***Ducted Systems
Technical Services
Service Tips Letter***

Letter: **ST-014-2018**

Subject: **3-12 ton Packaged Reheat – Resolution of 3-way valve issue.**

Product: **Series 10, Predator, Outfitter, Ovation, ReliaCore 300, OmniCore 300**

Figure 1.

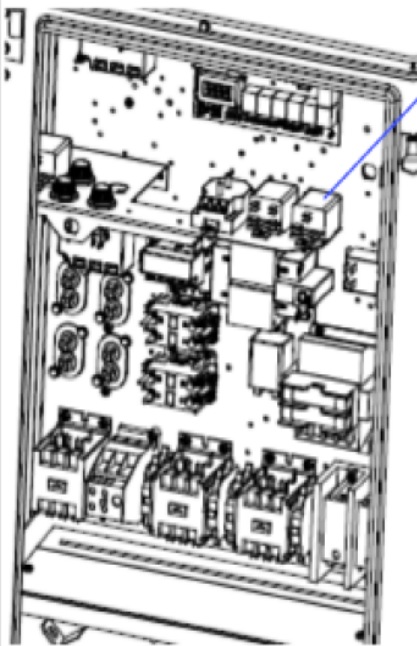
The following instructions are to provide direction to replace the current RHR (SPDT) with a (DPDT) relay with the addition of a Time Delay Relay. The purpose of this change is to provide a brief interruption of the compressor at the initiation of a call for dehumidification only and allow the Reheat Valve to fully shift to the reheat mode.

1. Open the controls access door and locate the reheat relay, as shown in Figure 1
2. Disconnect all wires from the reheat relay and remove the (2) screws securing the reheat relay. Discard relay

3. Install the new reheat relay DPDT, secure using (2) screws removed from previous step
4. Install ICM102 time delay relay
5. Connect wiring as described in steps 6 thru 13, refer to Figure 2 below as needed

Figure 2.

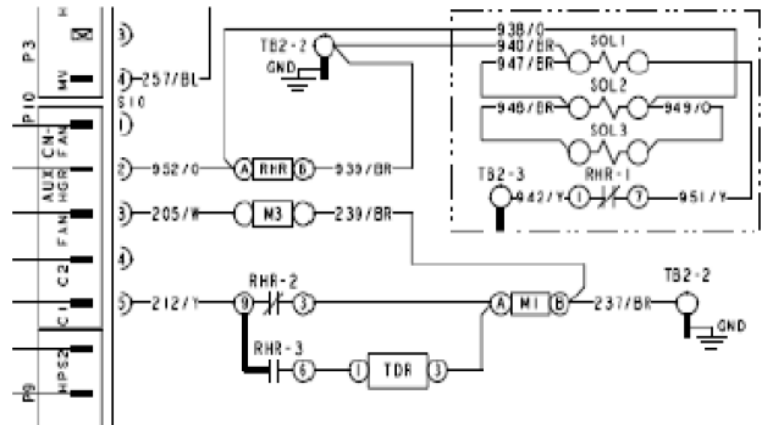
6. Connect wires 938/O and 952/O from UCB-AuxHGR and SOL2 to terminal 'A' on the new RHR relay
7. Connect 939/BR from TB2-2 to terminal 'B' on the new RHR relay

8. Connect 951/Y from SOL1 to terminal '7' on the new RHR relay
9. Connect 942/Y from TB2-3 to terminal '1' on the new RHR relay
10. Disconnect 212/Y for compressor contactor M1-A and re-connect to terminal '9' on the new RHR

11. Connect a new wire from compressor contactor M1-A to terminal '3' on the new RHR relay
12. Connect a new wire from terminal '1' on ICM102 to terminal '6' on the new RHR relay

13. Connect a new wire from terminal '3' on ICM102 to compressor contactor M1-A, since there may be only one terminal available on M1-A, a piggyback terminal may be required

14. The time delay relay ICM102 is adjustable up to 10 minutes. It is recommended to set the red dial to the 2-minute mark
15. After the time delay is set, close the controls access door, restore power to the unit and confirm unit operation
